UNITED STATES PATENT AND TRADEMARK OFFICE

Office Action Summary	Application No. 10/565,101	Applicant(s) ISHIKAWA ET AL.	
	Examiner AMANDA BARROW	Art Unit 4111

DETAILED ACTION

Fig.1

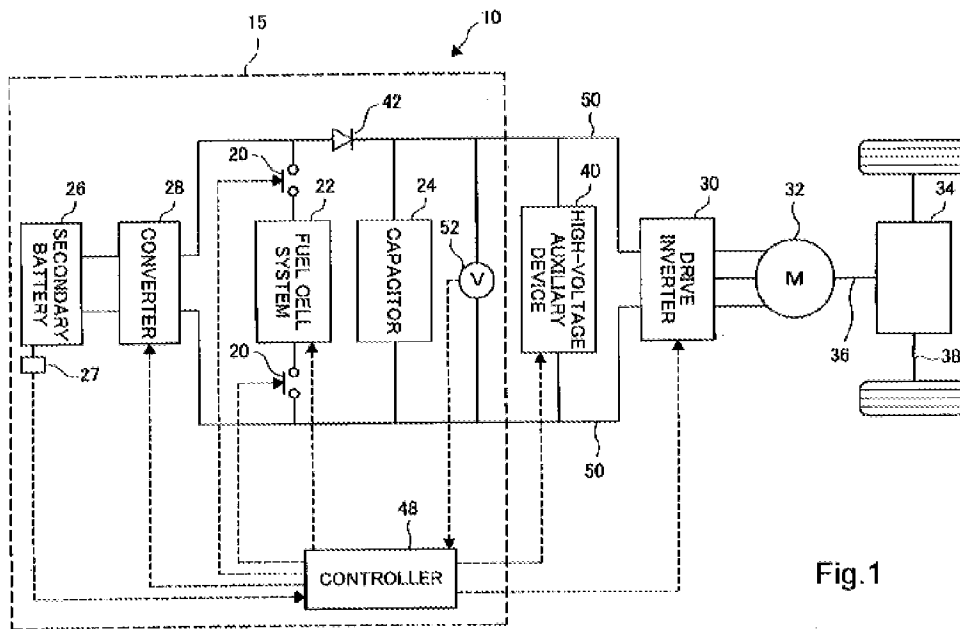
4. Regarding claim 1, Sugiura teaches a fuel cell system (22) including a fuel cell (60), electric power storing device (capacitor 24), and electric power supplying device (power supply apparatus 15) for supplying electric power to a load (high-voltage auxiliary machine 40) from the fuel cell (60) and the electric power storing device (power supply apparatus 15) as illustrated in Figures 1 and 2 below:

The electric power supply device (power supply apparatus 15) includes intermittent operation means (FC suspend mode or "intermittent operating mode" – paragraphs 54-55) for stopping operation of the fuel cell (60) when an amount of electric power required by the load is smaller than a reference value (reference voltage value V_0 - paragraph 59) :

Regarding claim 7, Sugiura teaches that the fuel cell system (22) has an electric power storing device (capacitor 24) that includes at least one of a secondary battery (26) or capacitor (24). This is shown in Figure 1 above and Sugiura's fuel cell system (22) contains both.

Regarding claim 8, Sugiura teaches an electric vehicle (10) including a motor (32) that generates power for the vehicle and a fuel cell system (22) that includes electric power supplying device (power supply apparatus 15) for supplying electric power to the motor (32) from a fuel cell (60) shown in Figure 1 above. The remainder of the claim is identical to claim 1 so please see the arguments regarding claim 1 for the rejection of claim 8.

Fig.4(B)

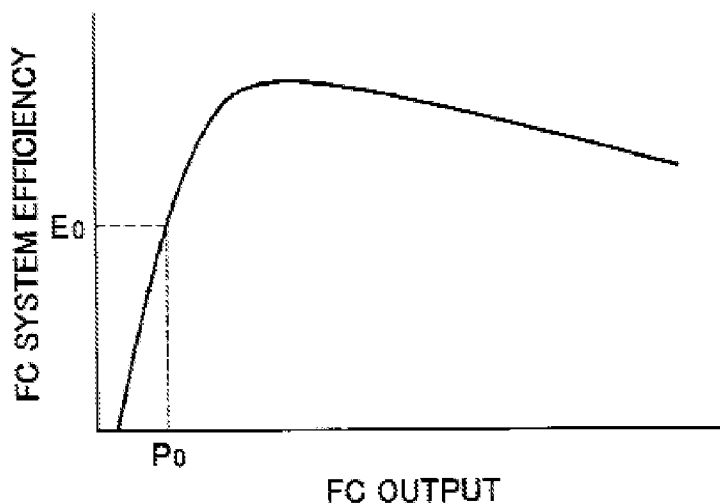
Also, figure 4B (shown below) shows the relationship between the output and energy efficiency of the fuel cell 60. "The value of the output voltage, or output power, ...changes depending on the internal temperature of the fuel cell 60," (paragraph 46); therefore, it is obvious that the output power on the graph, P_0 , which is related to the output voltage of the fuel cell, will have a different value and therefore the reference value is adjusted. For a more detailed explanation, please see paragraphs 46, 56, 57, 78 and 79. Also, the threshold adjusting means is more plainly stated in paragraph 78:

advanced. This is not explicitly stated but can be inferred from the information given. As already stated and shown in Figure 4B, there is a relationship between the level of output and the energy efficiency of the fuel cell. The value of the output voltage or output power is dependent upon the internal temperature of the fuel cell (paragraph 46). If the temperature decreases, so does the power output which causes P_0 to change position in Figure 4B. Temperature also affects the internal electromotive force (open circuit voltage). As the desired efficiency of the fuel cell is established and knowing that temperature changes the power output, these variables including the second reference value (V2) will increase or decrease depending upon the situation as the power output is related to the voltage.

Fig.8

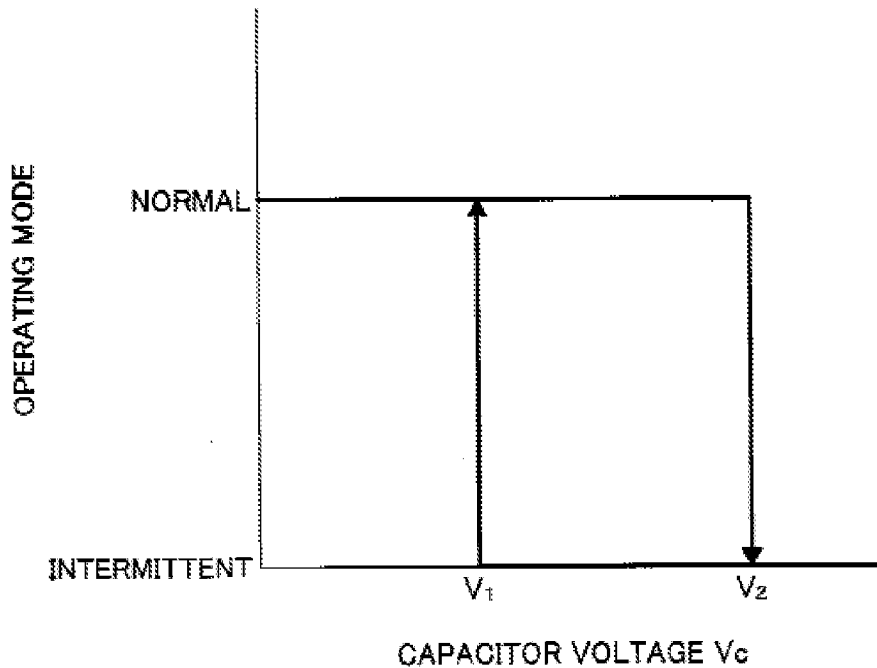
Regarding claim 4, Sugiura teaches that the fuel cell system (22) has a first reference value (V_1) and second reference value (V_2) that is larger than the first value and the intermittent operation means stops the operation of the fuel cell (30) when the amount of electric power required by the load is smaller than the first reference value (V_1) and starts the stopped operation of the fuel cell when the amount of electric power required by the load is equal to or larger than the second reference value (V_2):

"Figure 8 (shown below) shows two different reference voltages for use in the determination of switching between the intermittent driving mode and the FC suspend mode. In this embodiment, the first reference voltage V_1 used when the mode is to be switched from the FC suspend mode to the normal operating mode is set to be lower than the second reference voltage V_2 used when the mode is to
